CITY PLAN COMMISSION STAFF REPORT

Martin City Apartments

CD-CPC-2021-00125 - Rezoning with plan

Report Date: October 01, 2021
Case Number: CD-CPC-2021-00125
Project: Martin City Apartments

C001 COVER SHEET

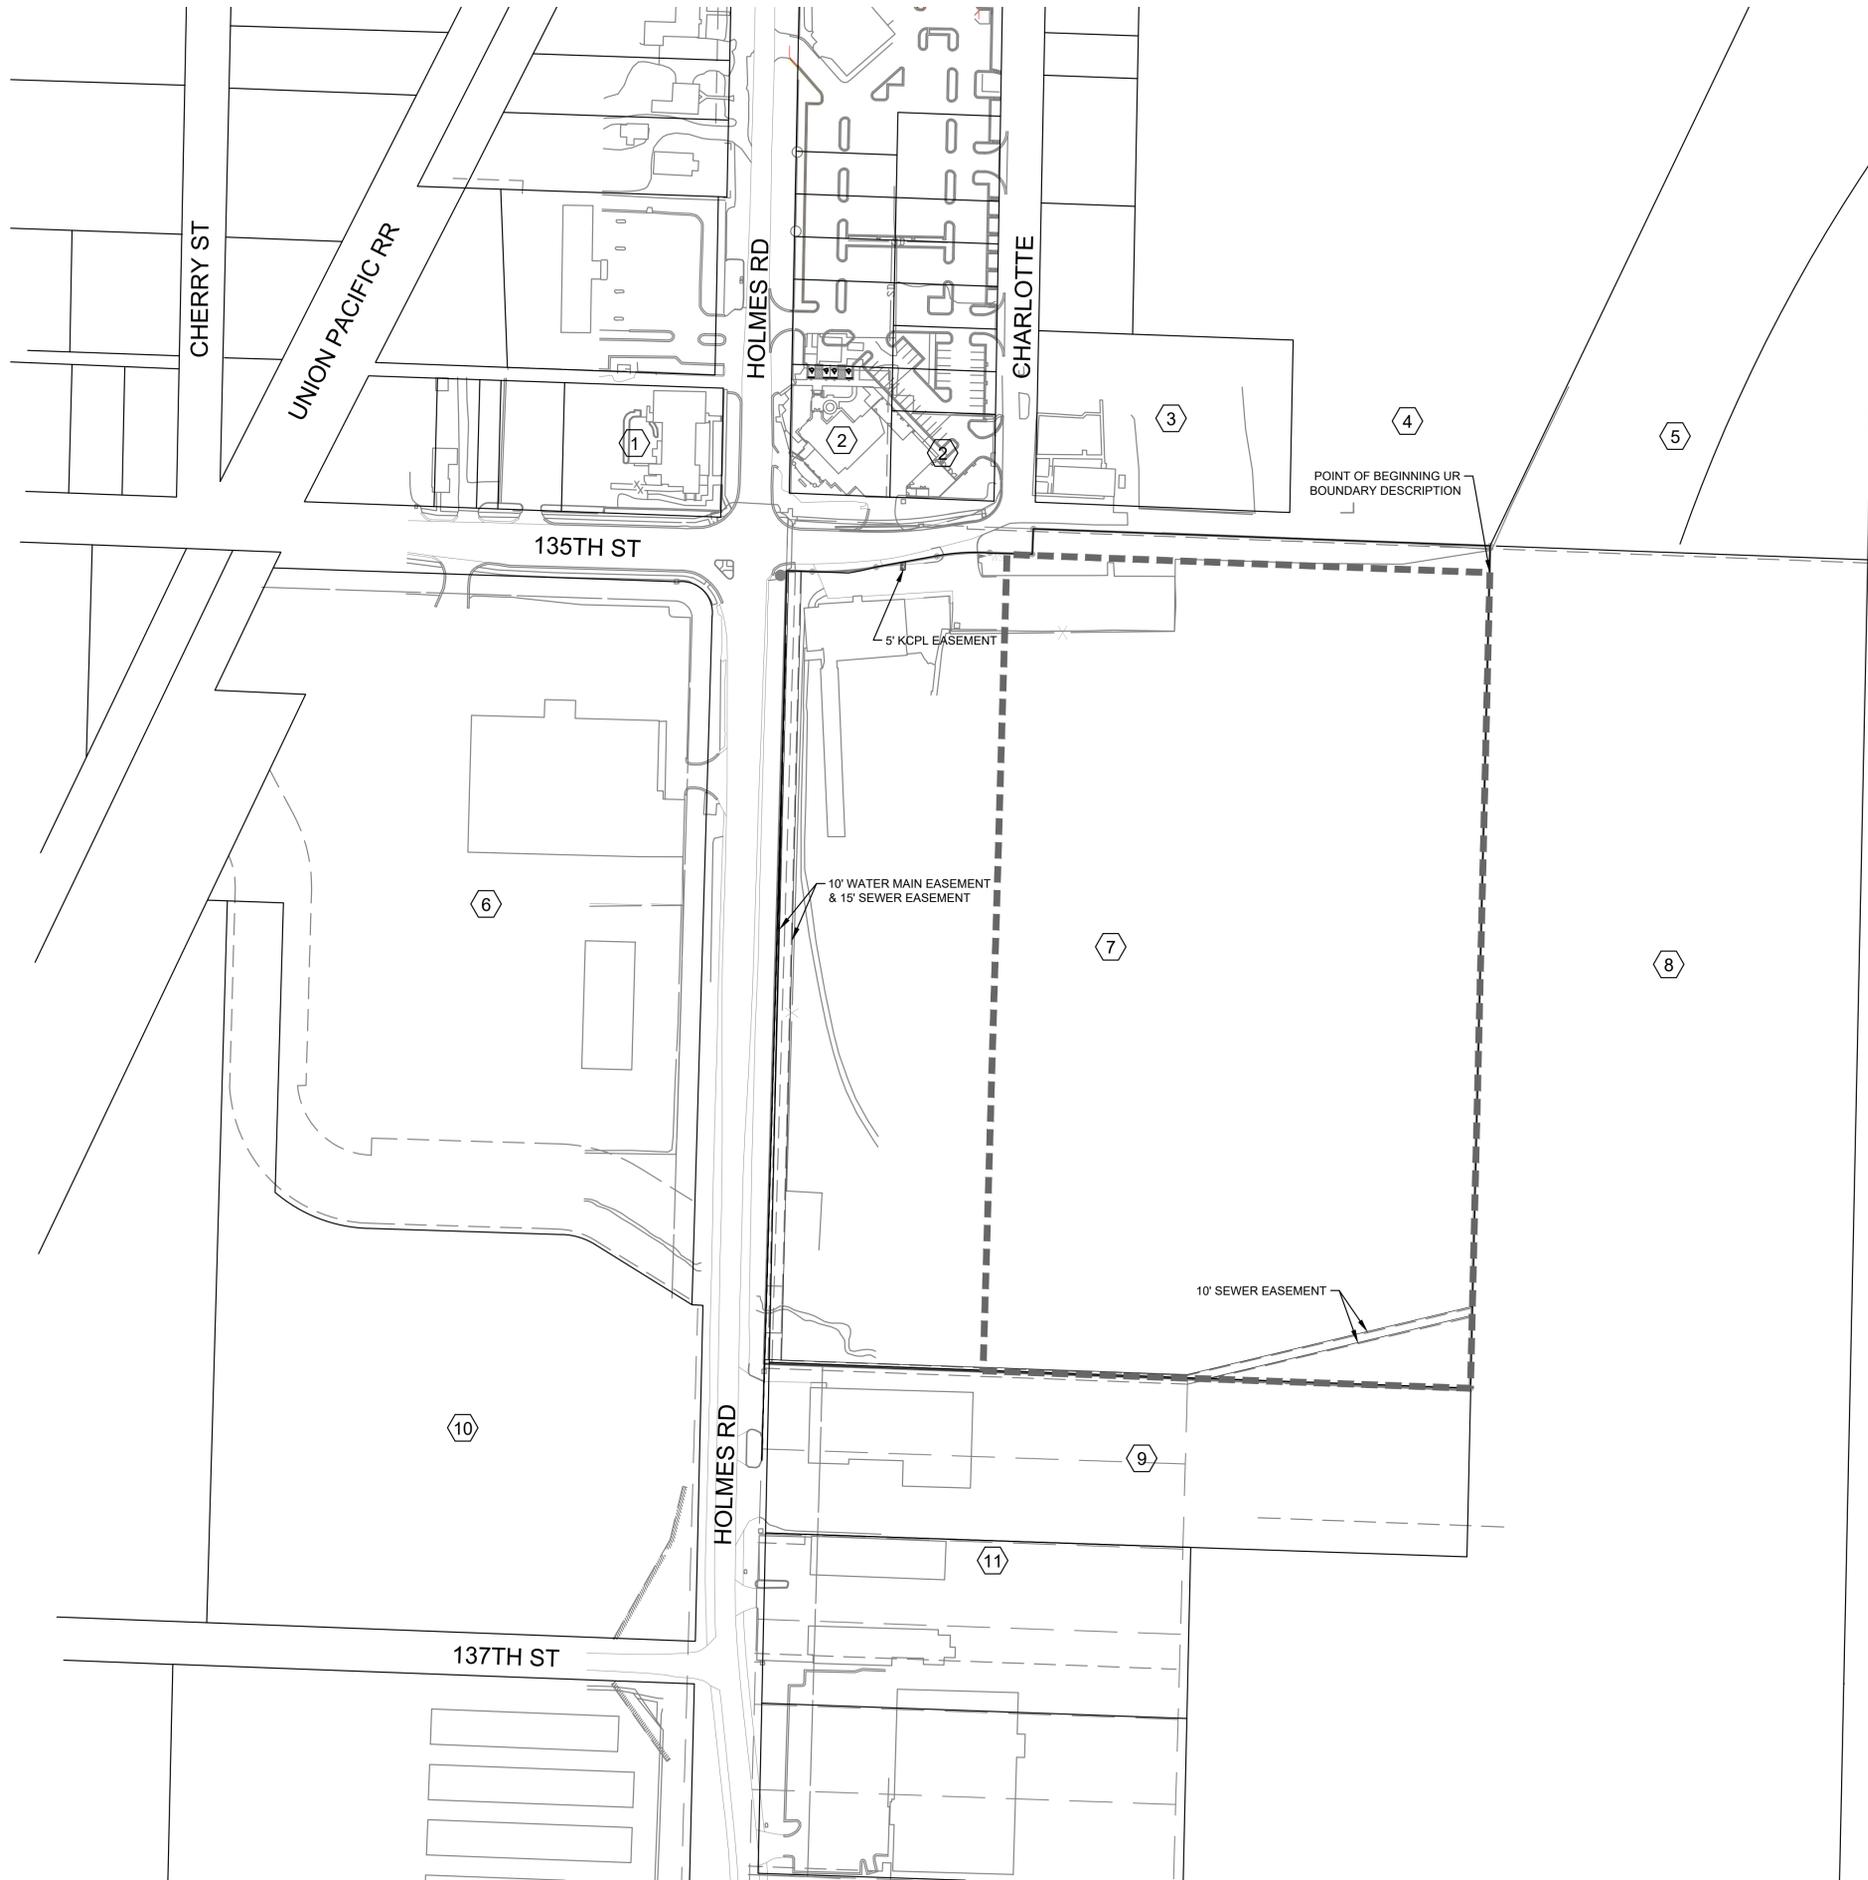
The standards of this section apply because this is a UR Development plan. The plan shows 218 parking spaces (35 garages) which exceeds the number of spaces required by the Zoning and Development Code. Staff recommends that the parking table be revised to show correct number of and location of garages, covered parking and ADA parking spaces.

5. Revise parking table to show correct number of and location of garages, covered parking and ADA parking spaces. Revise Plans and Resubmit (10/01/2021)

sheet number
C003 PROPOSED SITE PLAN
drawing type
ur rezoning plan
project number
77-1610

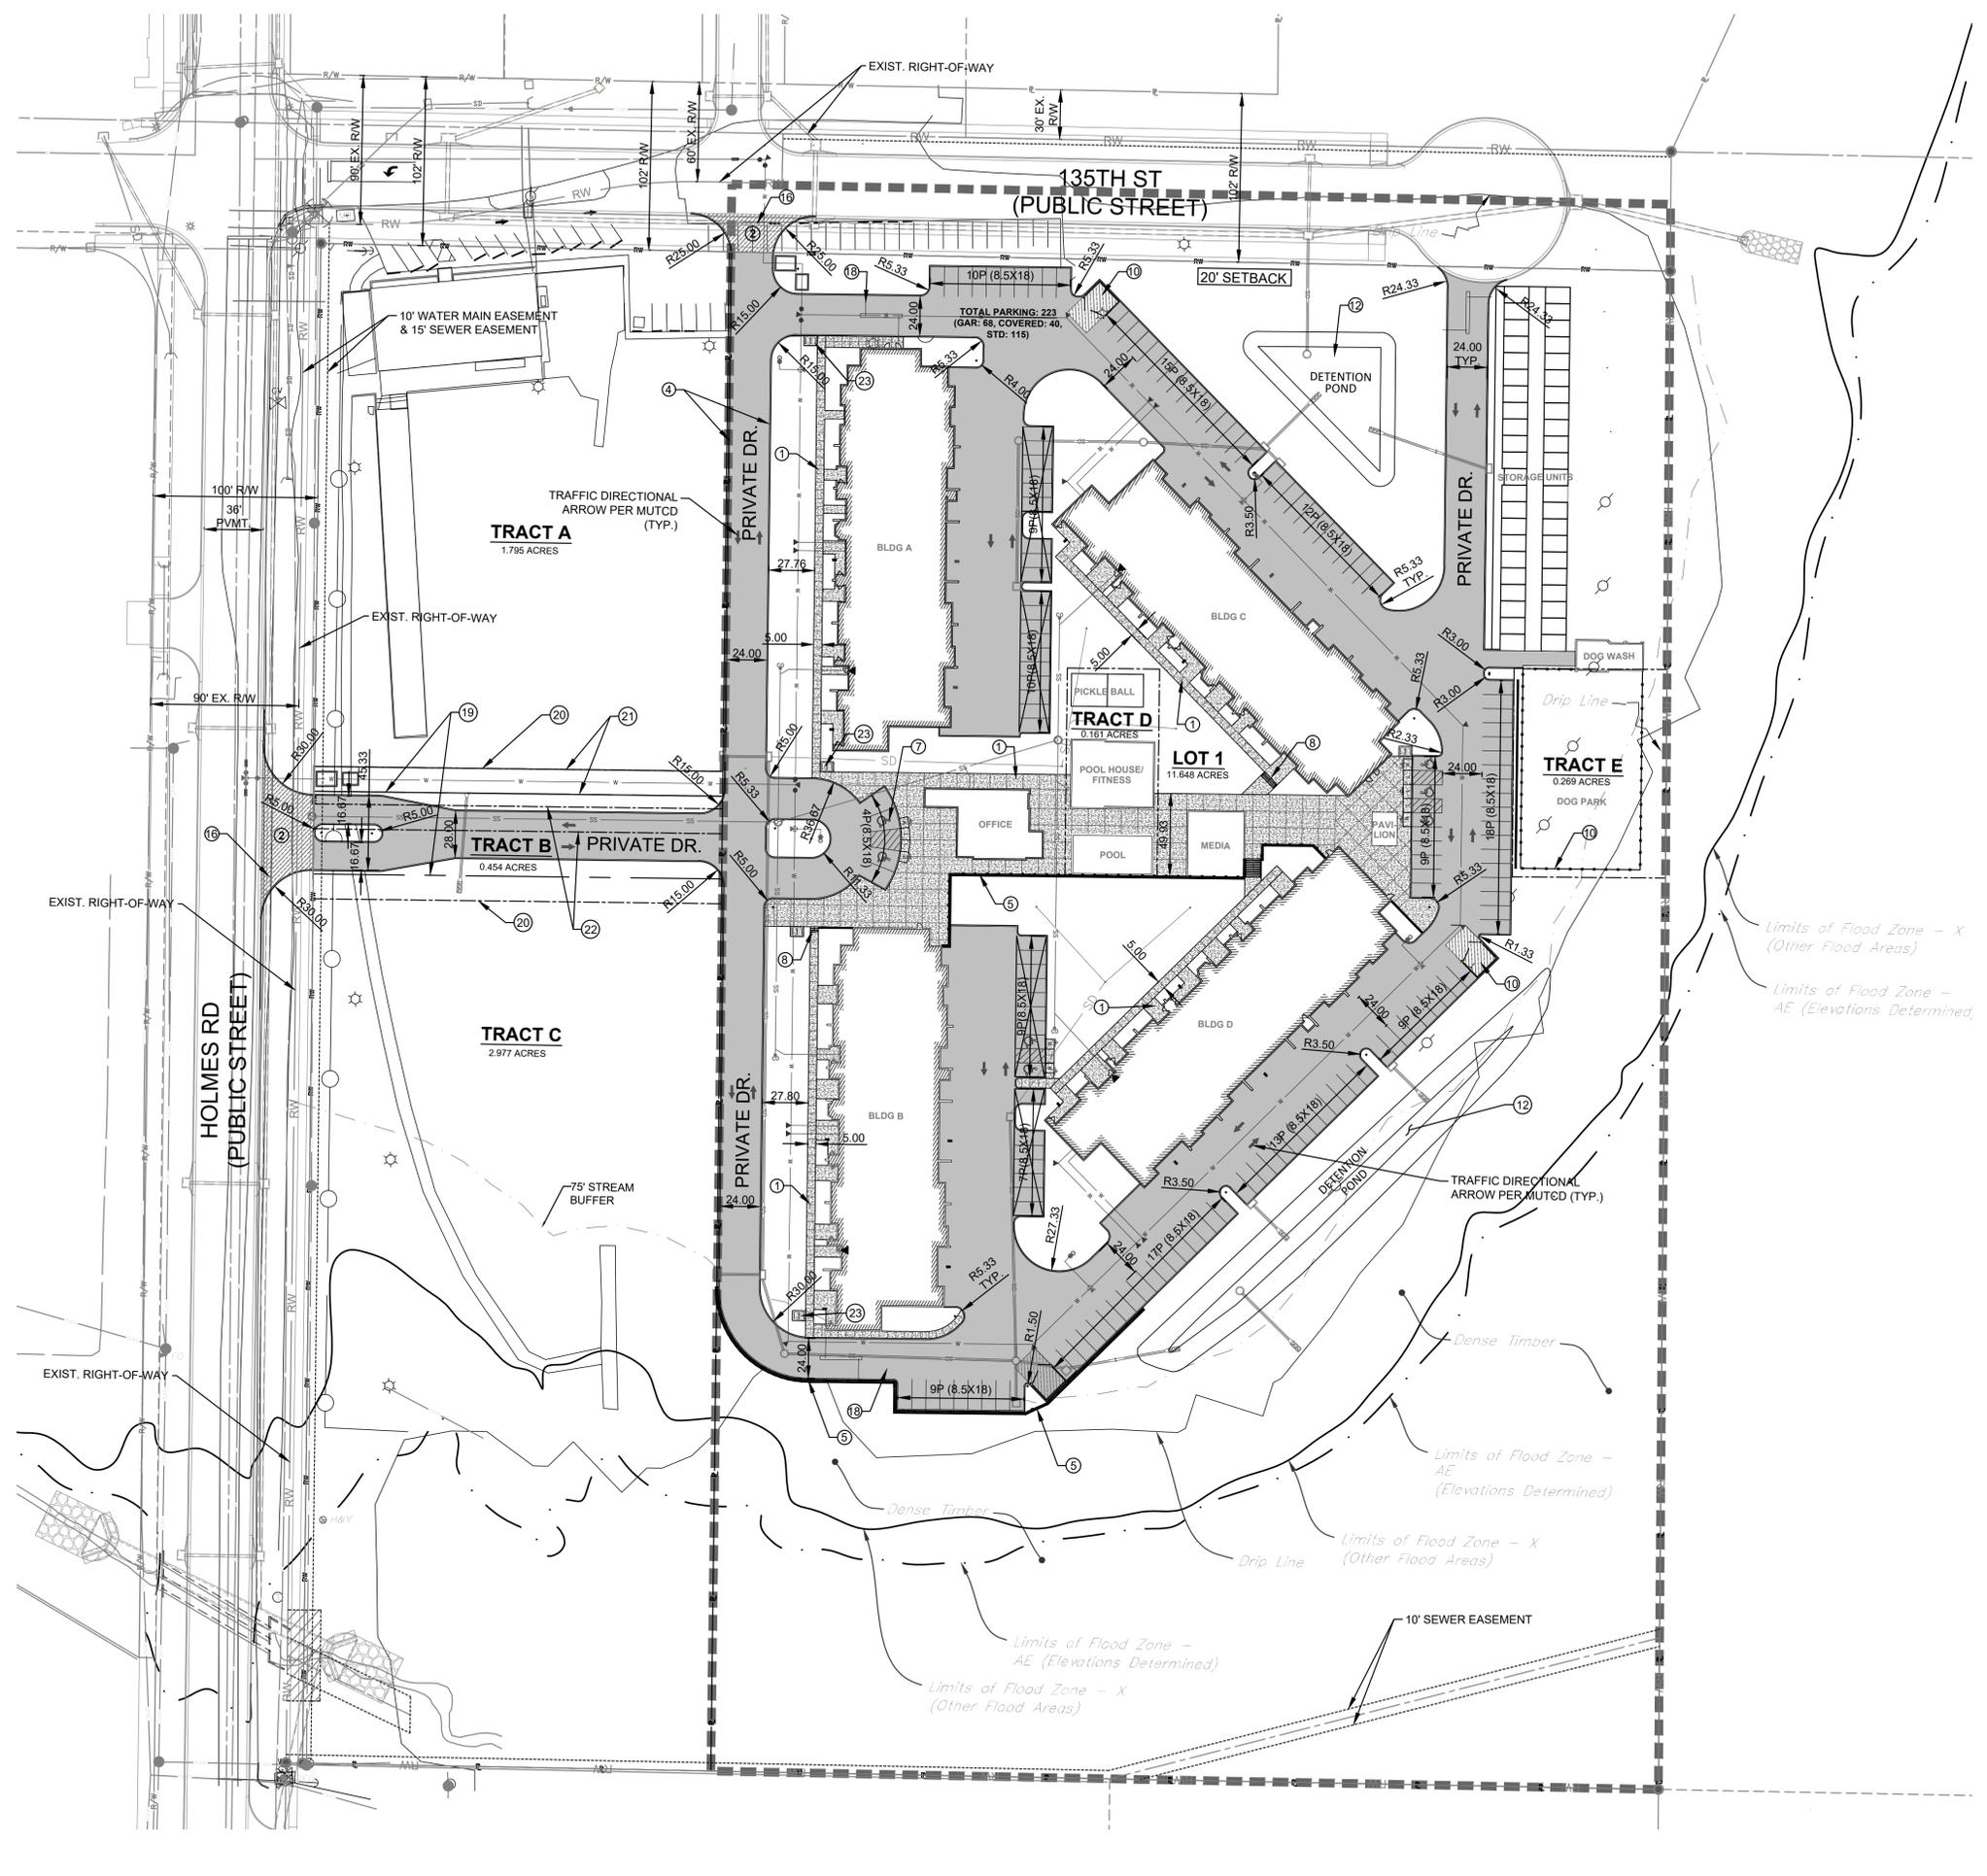
3. Submit two separate legal descriptions in word document format.
 1. UR rezoning boundary.
 2. Preliminary plat boundary. (9/27/2021)
4. Dimension parking lot setback along E. 135th Street. (9/27/2021)

6. Revise plan to show walkability and pedestrian circulation within the development connecting to the public streets (Holmes Road and E. 135th Street). The internal sidewalks can be differentiated with different texture, material or paint to discourage vehicular parking. Revise Plans and Resubmit (10/01/2021)
